SERVICE BULLETIN

KAIR10001 – TANARG Fuel Tank

LANAS 16 April 2010

Re : Potential cracks in TANARG fuel tanks.

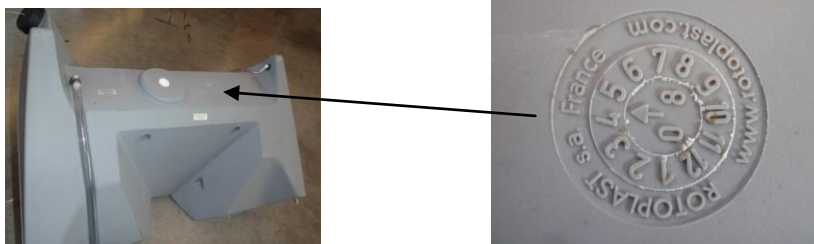
TRIKES CONCERNED : The TANARGs whose fuel tank was manufactured in since January 2008. (stamp visible as shown in the figures hereunder 08-04 or April 2008):

Potential appearance of cracks leading to fuel leaks.

Regular and careful checks must be made and before every flight, in case of the appearance of cracks you should stop flying and contact our aftersales service for a replacement part.

It may prove useful to disassemble the keel of the trike (lower fairing) in order to gain visual access to the areas at risk.
